STATE OF NORTH CAROLINA  
UTILITIES COMMISSION  
RALEIGH

DOCKET NO. E-100, SUB 179

In the Matter of:  
Duke Energy Progress, LLC, and Duke ) JOINT COMMENTS OF  
Energy Carolinas, LLC, 2022 Biennial ) NC WARN AND THE  
Integrated Resource Plans and Carbon Plan ) CHARLOTTE  
) MECKLENBURG NAACP

<sup>45</sup> Carbon Plan, Appendix E, p. 40, Figure E-6: Base Henry Hub Natural Gas Price Forecast [\$/MMBTU]

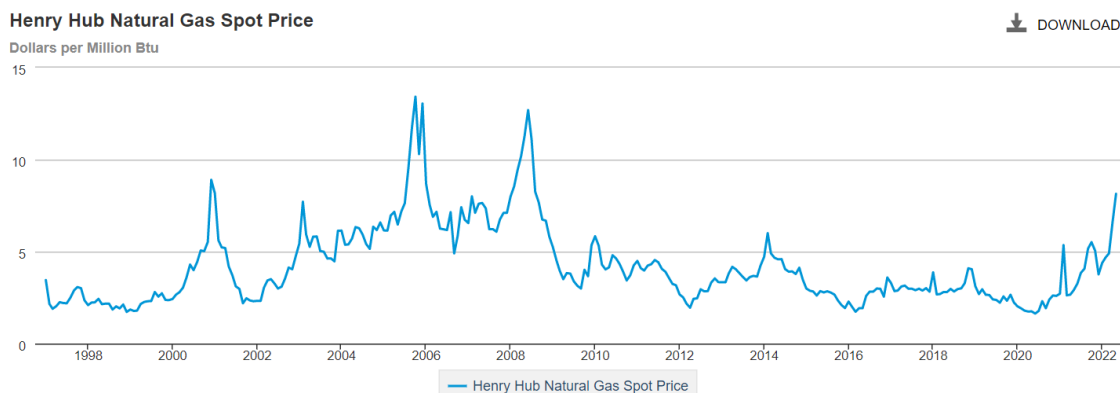
The Companies’ proposed natural gas buildout is further problematic because of the Carbon Plan’s unreasonably optimistic projection of future natural gas prices. The Carbon Plan assumes a low base price for natural gas of under \$4/MMBtu through 2032, rising to \$5/MMBtu in 2040. The Carbon Plan included Figure E-6, which depicted a Henry Hub natural gas price forecast utilized in the Carbon Plan modeling. Figure E-6 from the Carbon Plan is as follows:<sup>45</sup>

The Carbon Plan modeling of natural gas pricing does not properly account for the substantial price volatility which is presently inherent to the natural gas market. Below is a figure taken from Mr. Powers' Report which reflects the substantial historic Henry Hub benchmark natural gas price volatility:<sup>46</sup>

According to Mr. Powers, “[n]atural gas prices have been especially volatile in 2022, with the May 2022 Henry Hub price over \$8 per million Btu.”<sup>47</sup> In fact, “Western Europe has become a high demand priority delivery point for U.S. natural gas in the form of LNG in the wake of the Ukraine war, driving increases in U.S. natural gas prices.”<sup>48</sup> Given these circumstances, the Companies’ projection of natural gas prices is unreasonably optimistic and should be rejected.

(f) The Companies should correct their unrealistic natural gas price projections.

**Figure 8. Comparison of Duke Energy actual demand growth to forecast demand growth<sup>78</sup>**

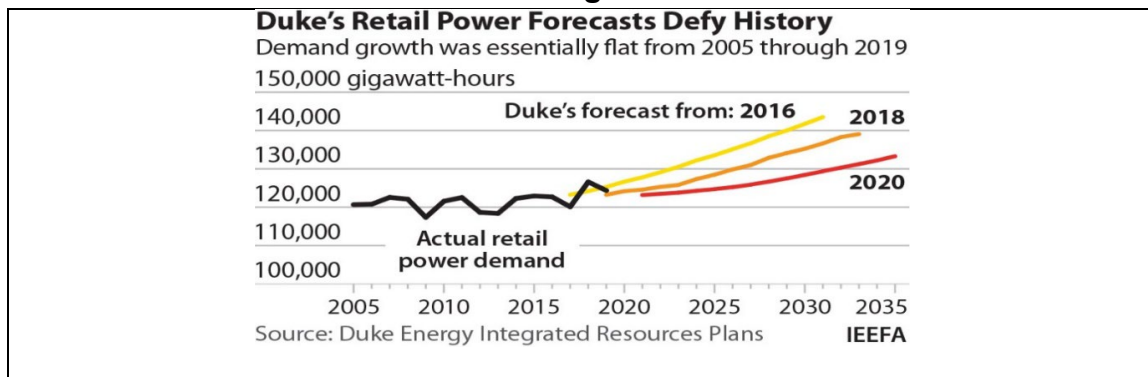
The Companies’ proposed natural gas buildout is largely based upon the purported need for new generation assets due to the substantial projected demand growth predicted in the Carbon Plan.<sup>77</sup> At the outset, it should be noted that the Companies have consistently overstated their demand growth during the last several Integrated Resource Plan proceedings, and the Companies’ aggressive projections have not come true. The following Figure 8, cut-and-pasted from Mr. Powers’ Report, illustrates the Companies’ history of overstating demand growth:

Actual retail sales growth for DEC from 2016 through 2021, which is the most recent five-year period shown in the Carbon Plan, averaged 0.0 percent.<sup>79</sup> Instead of using this period, the Companies opted to analyze the period of 2012 to 2021 and thereby assert a sales growth rate forecast for DEC of 0.8 percent.<sup>80</sup> This number is skewed and unreliable because 2012 was an unusually low retail sales year, as reflected in the above-provided Figure 8.<sup>81</sup> By arbitrarily beginning the calculation of demand growth on 2012, the Companies were able to project a demand growth for DEC of 0.8 percent. However, the most recent—and reliable—trends, namely over the last five (5) years, reflect an average annual growth of 0.0 percent.<sup>82</sup>

A similar analysis applies to DEP. The Carbon Plan shows that retail sales for DEP declined from 2016 through 2021, the most recent five-year period, at a rate of -0.7 percent.<sup>83</sup> Hence the Companies arbitrarily expand their analysis to the 2012-2021 time period.<sup>84</sup> As noted, 2012 was an unusually low retail sales year. By pegging the analysis to 2012, the Companies project demand growth for DEP of 0.4 percent. This projected demand growth seemingly ignores that, over the last five (5) years, DEP's retail sales have declined at a rate of -0.7 percent.<sup>85</sup>

(l) The Companies should correct the above-described errors with their demand growth rate forecast.

(m) Based upon the results of the above-stated corrections, the Commission should require the Companies to revise and reduce their demand growth rate forecast.
